Please find below the response to the review formulated for the CDM project "Jidong Cement Jilin Co., Ltd 6 MW Cement Waste Heat Recovery Project" with the registration number 2851. In case you have any further inquiries please let us know as we kindly assist you.

## **Response to the CDM Executive Board**

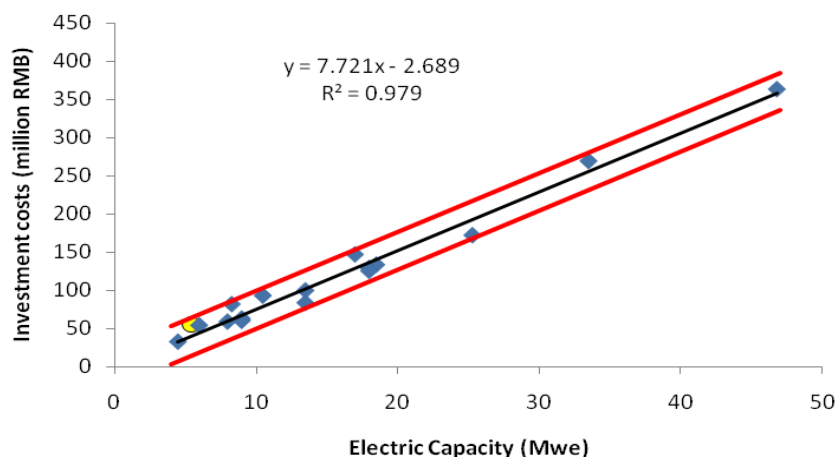
The EB requested to clarify in particular the investment cost. Below we will provide several arguments as to why the investment cost estimated by the licensed and qualified design institute is reasonable and appropriate. Firstly, we will compare the estimated investment cost to the total contracted amount by adding the values in the legally and financially binding contracts for construction and equipment. Secondly, we will in accordance with paragraph 54(c) of EB38, “crosscheck that the input values from the FSR are valid and applicable”, by comparing the total investment cost to the norm listed by the European Commission and by comparing the total investment cost of the proposed project activity to the investment costs of Chinese Cement WHR projects that are registered to date.

$$\text{Inv (million RMB)} = 7.721 \text{ Cap (MWe)} - 2.689$$

The correlation coefficient of  $R^2$  of 0.979 indicates a high correlation between the capacity and investment costs. The standard error of 12.49 has been calculated based on the difference between the predicted (theoretical) values and the investment costs listed in the PDDs.

The figure below depicts a regression analysis assuming a linear relationship between the investment costs in RMB and installed capacity in MW for similar cement WHR projects. The proposed project activity (yellow dot) is well within 2 standard errors (indicated with red lines) from the black trend line, which means that the estimated Investment cost of the project activity is similar to the investment cost of similar projects. Hence, we can conclude our “crosscheck”, such as the contracted values, in accordance paragraph 54(c), EB38, that an IRR calculation based on the Investment costs of the FSR which we have conducted is conservative as low investment cost will result in an overestimation of the IRR.

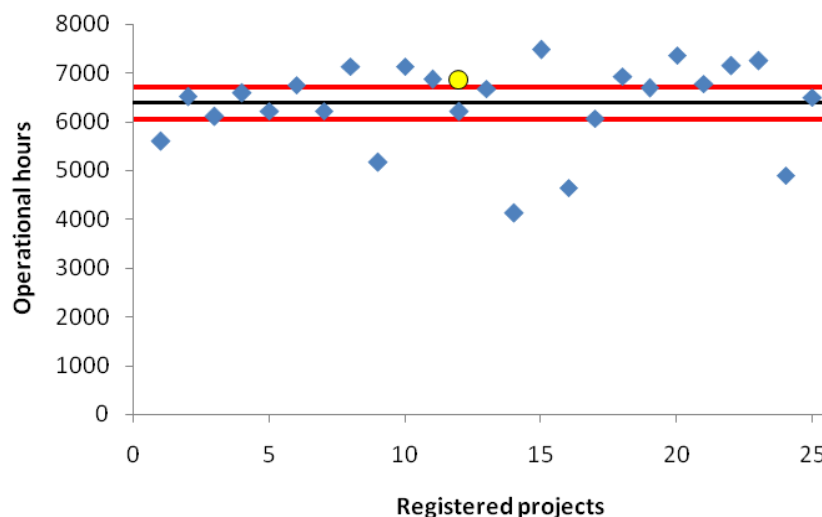
The figure below depicts a scatter plot the operational hours on the vertical axis and each similar project on the horizontal axis. Please note that the location of the project along the horizontal axis is random. The proposed project activity is above the 95% confidence level; hence we can conclude the operational hours are conservative in comparison to similar projects since more operational hours will result in an overestimation of the IRR.

conclude that our IRR calculation base on the high estimates is *conservative* as this high estimated power generation will result in an overestimated IRR.
